## CITY OF SARATOGA SPRINGS

**Concept Plan  
Harbor Point  
March 27, 2014  
Discussion and Feedback**

Report Date:	Thursday, March 20, 2014
Applicant:	Land Solutions Partners – Harbor Point LLC
Owner:	Same
Location:	Approximately 4200 South Redwood Road
Major Street Access:	Redwood Road
Parcel Number(s) & Size:	16:003:0034, 11.087 Acres
General Plan Designation:	Low Density Residential
Parcel Zoning:	R-3
Adjacent Zoning:	R-3, R-2, A
Current Use of Parcel:	Vacant
Adjacent Uses:	Residential, Vacant
Previous Meetings:	None
Previous Approvals:	None
Land Use Authority:	City Council
Future Routing:	Informal review with City Council prior to Preliminary Plat
Author:	Kimber Gabryszak, Planning Director

**Author:** Jeremy D. Lapin, City Engineer  
**Subject:** Harbor Point – Concept Plan  
**Date:** March 27, 2014  
**Type of Item:** Concept Plan Review

*Applicant:* Land Solutions Partners – Harbor Point LLC  
*Request:* Concept Plan  
*Location:* 4250 S. Redwood Road  
*Acreage:* 11.10 acres - 25 lots

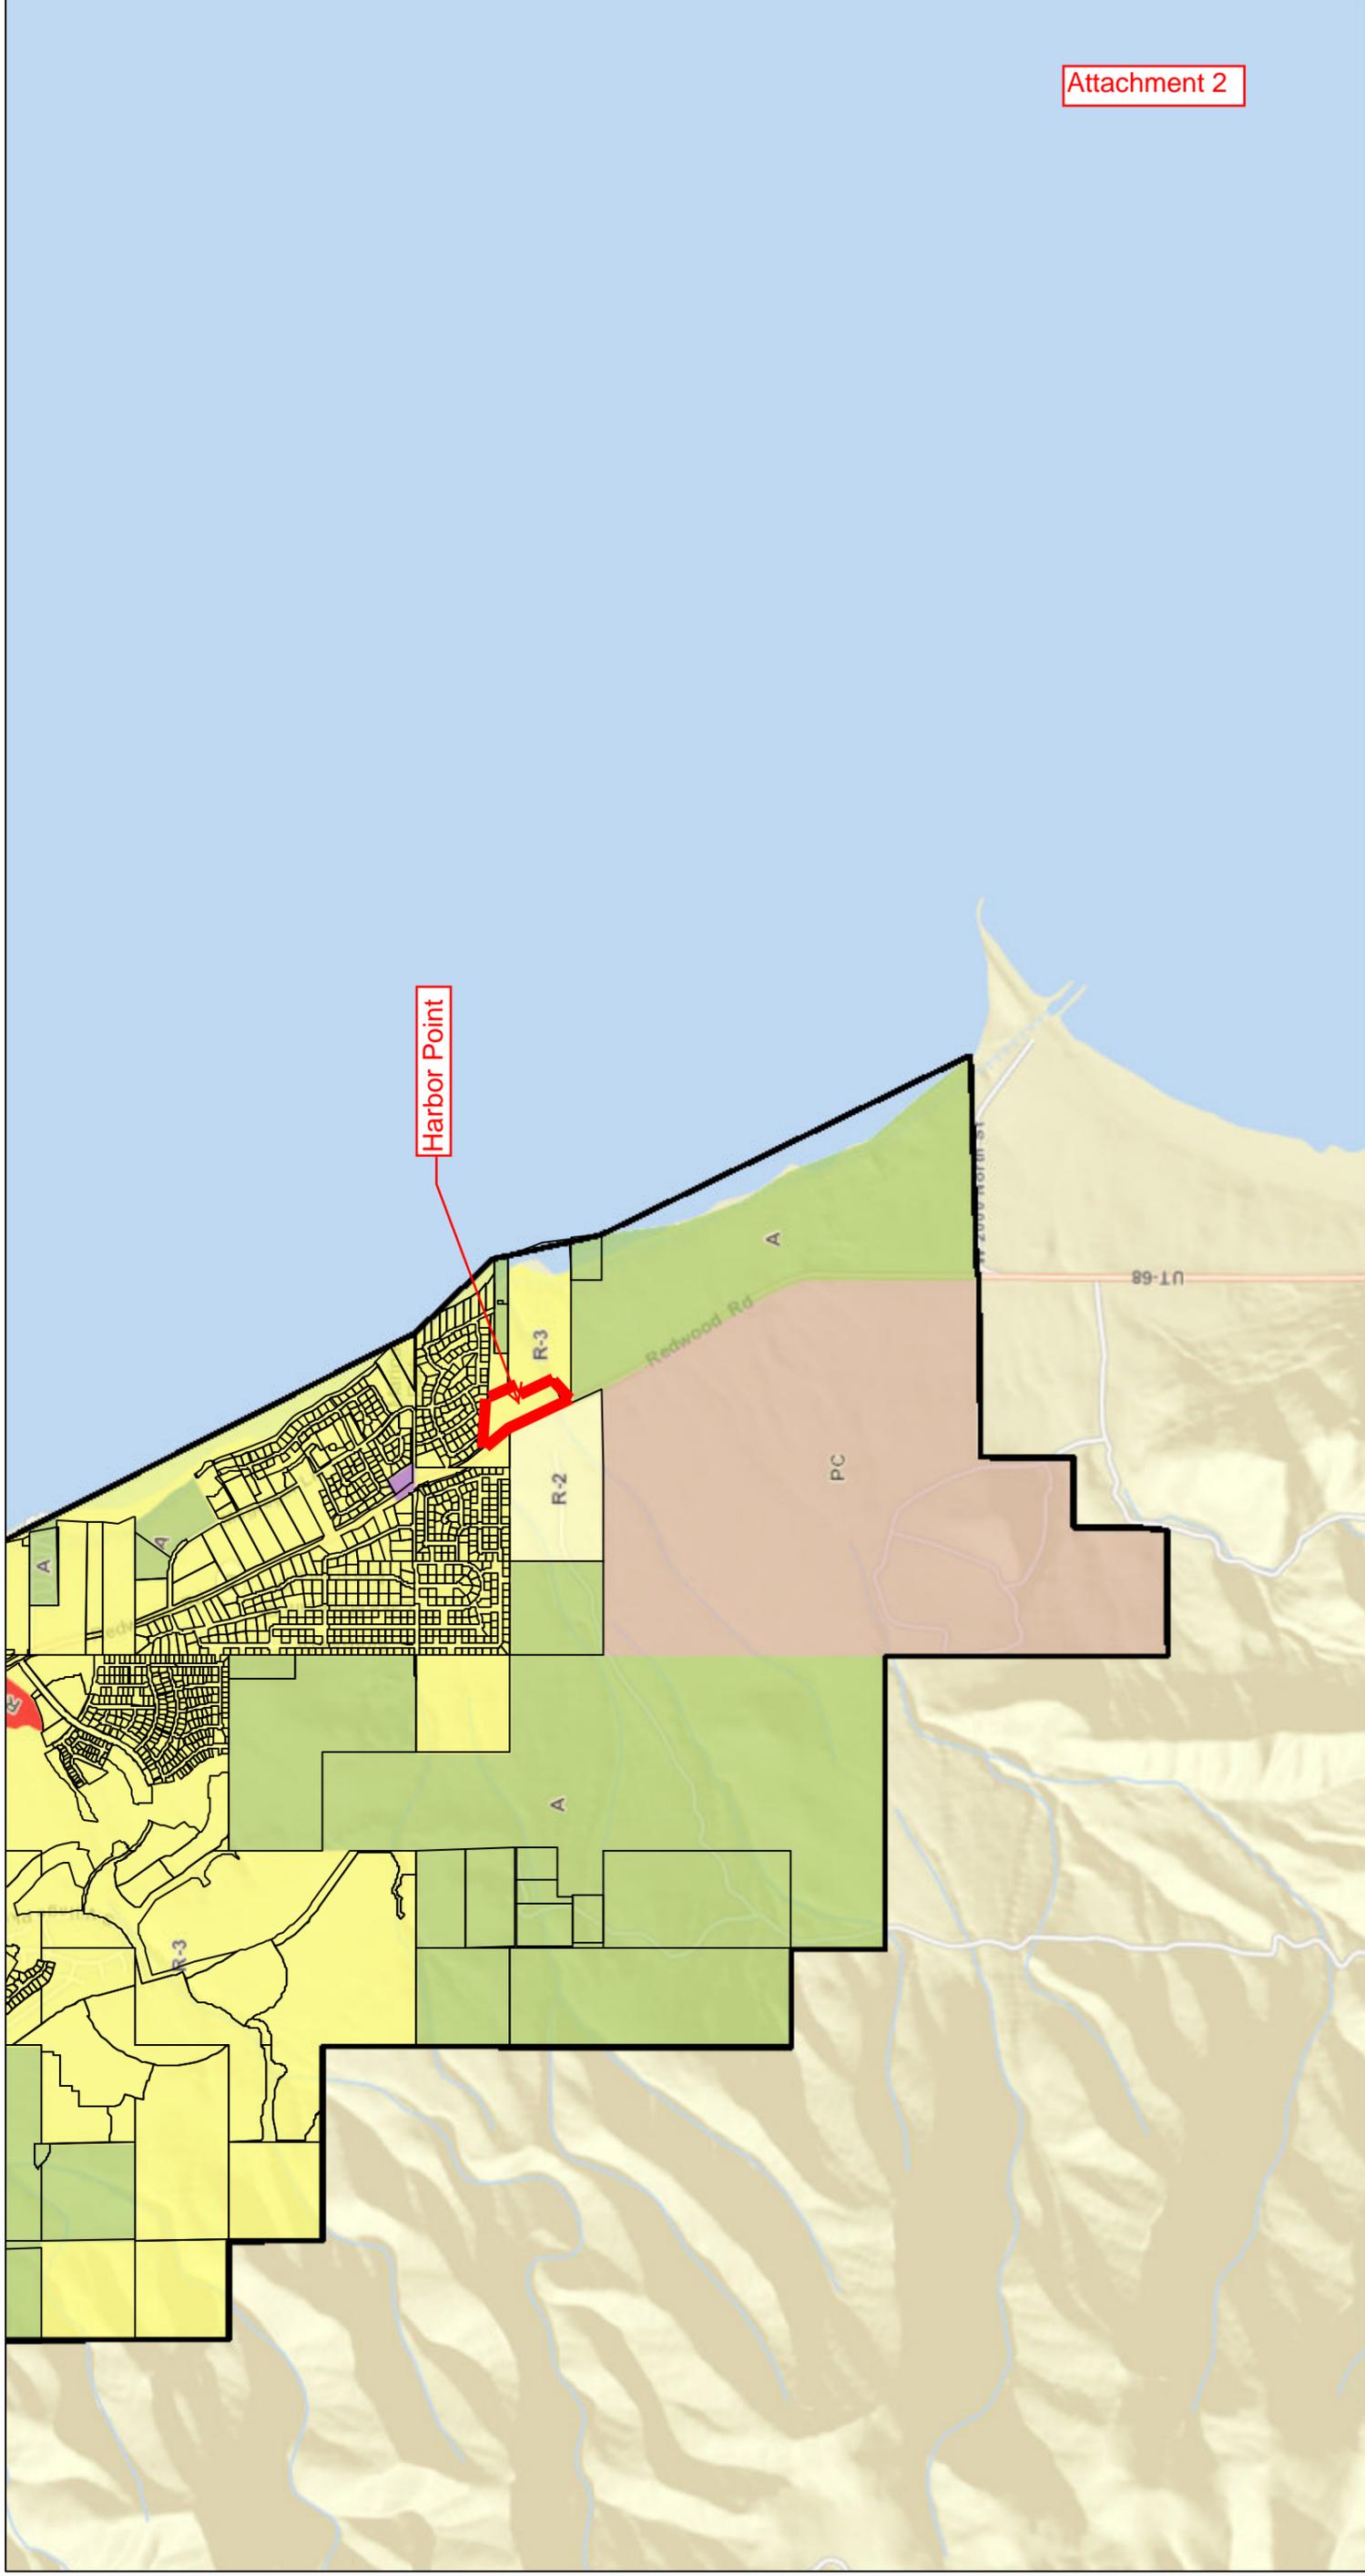
- A. Prepare construction drawings as outlined in the City’s standards and specifications and receive approval from the City Engineer on those drawings prior to receiving Final approval from the City Council.
- B. Consider and accommodate existing utilities, drainage systems, detention systems, and water storage systems into the project design. Access to existing facilities shall be maintained throughout the project.
- C. Comply with the Land Development Codes regarding the disturbance of 30%+ slopes.
- D. Incorporate a grading and drainage design that protects homes from upland flows.
- E. Developer shall provide a traffic study to determine the necessary improvements to existing and proposed roads to provide an acceptable level of service for the proposed project.

- F. Project must meet the City Ordinance for Storm Water release (0.2 cfs/acre for all developed property) and all UPDES and NPDES project construction requirements.

- K. Developer shall bury all existing overhead utilities on and adjacent to the project.
- L. Developer shall route all drainage from detention basin to lake. The developer is responsible to install all improvements and to obtain any necessary easements.

- M. Developer shall comply with the Land Development Codes regarding not disturbing 30%+ slopes.
- N. Existing drainages shall be preserved, improved with native landscaping and trails, and piped with culverts capable of passing the 100-yr flow where they cross roadways. A culvert under Redwood Road or other acceptable improvements to protect future homes from flooding will necessary to mitigate flows from all upland contributing drainage basins. . The developer is responsible to install all improvements and to obtain any necessary easements.

- O. The existing secondary water system cannot support this project. An additional source is required in the area to alleviate the extreme pressure swings that the current system would experience if this project is added. Although the culinary system could support both the indoor and outdoor demand for this project, this would use up significant amounts of the remaining capacity in the system and is not recommended.

- P. Frontages along Redwood Road will need to be improved to City standards including road widening, an 8' meandering trail, and dedication of a 90' half width ROW.
